**Addendum No. 1
To Contract Documents and Specifications**

**Alternate Raw Water Transmission Line
FEMA-1952-DR-CA CA OES ID:059-91099**

Project No. 6177

November 18, 2016

ATTACHMENT A

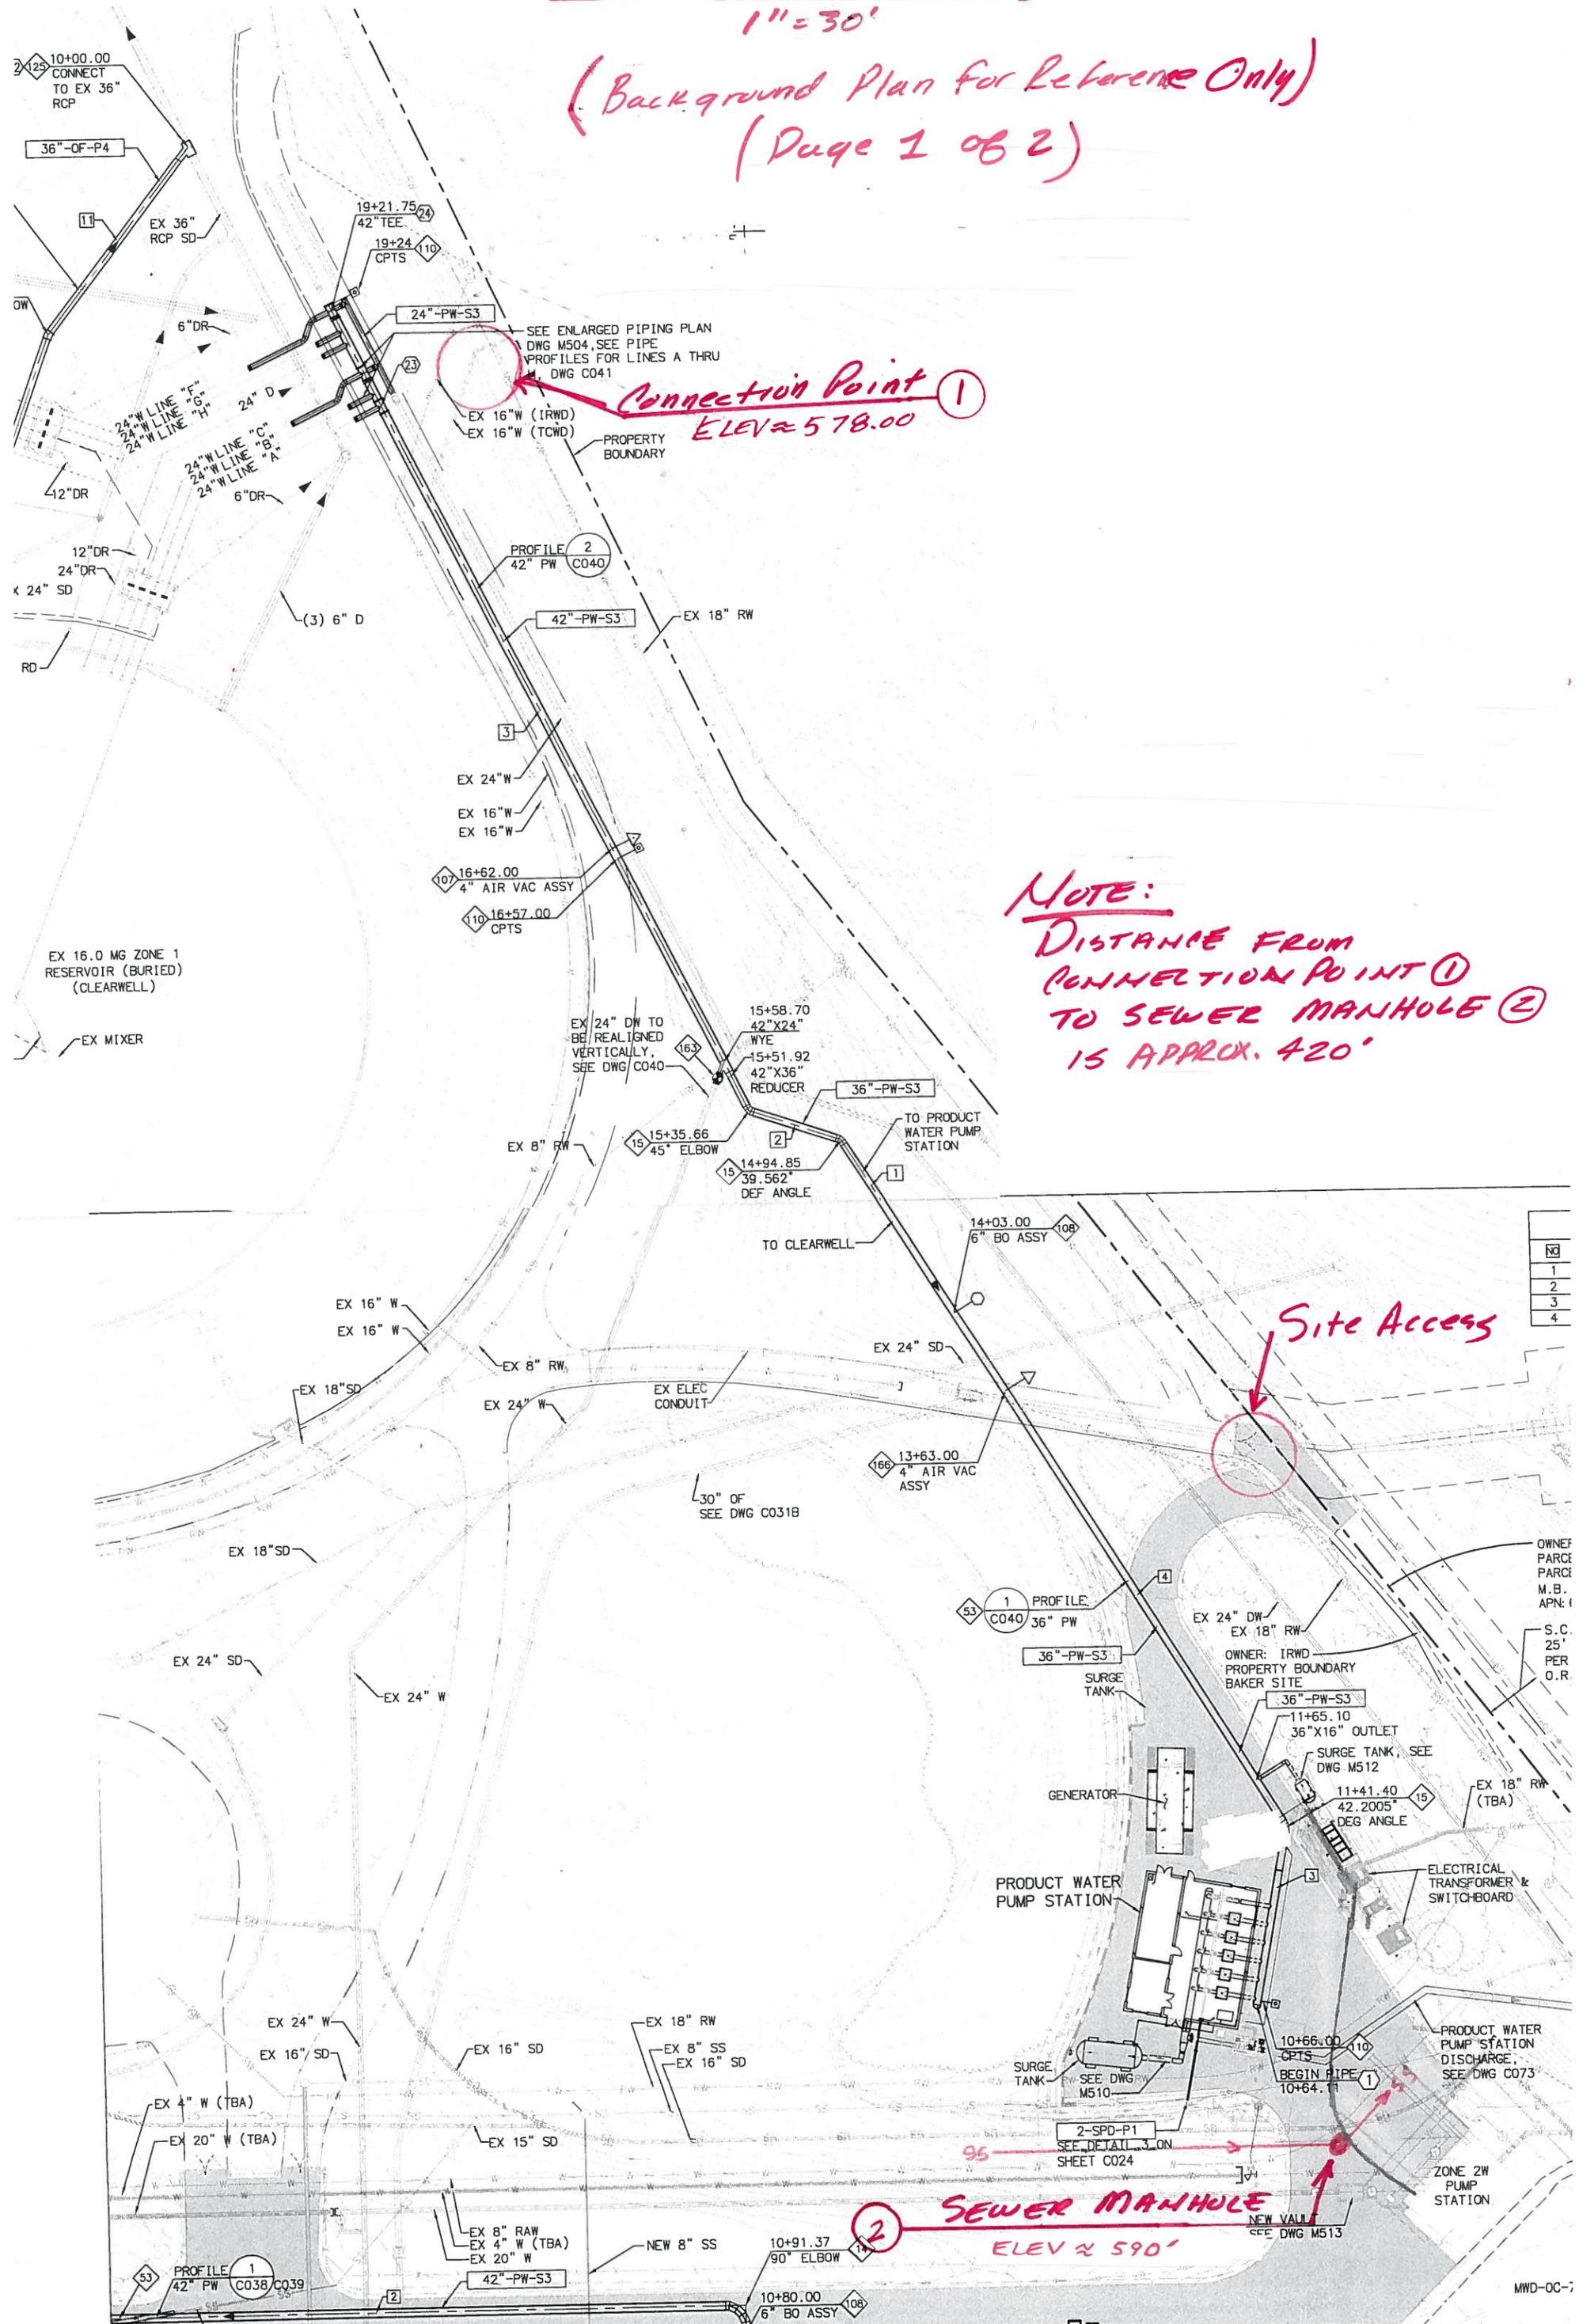
"Along the hiking trail, there are two points of potential disposal locations. One is located on the Baker Plant facility and the second is located at the north end of the trail near XP Logistics. The Contractor is responsible for all pumping, storage and transport to these points. The maximum discharge rate allowable is 150 gallons per minute. All work must be coordinated with IRWD and TCWD two weeks prior to discharge. These locations are as shown in Attachment A at the END OF SECTION"

"Along the hiking trail, there are two points of potential disposal locations. One is located on the Baker Plant facility and the second is located at the north end of the trail near XP Logistics. The Contractor is responsible for all pumping, storage and transport to these points. The maximum discharge rate allowable is 150 gallons per minute. All work must be coordinated with IRWD

and TCWD two weeks prior to discharge. These locations are as shown in Attachment A at the END OF SECTION”
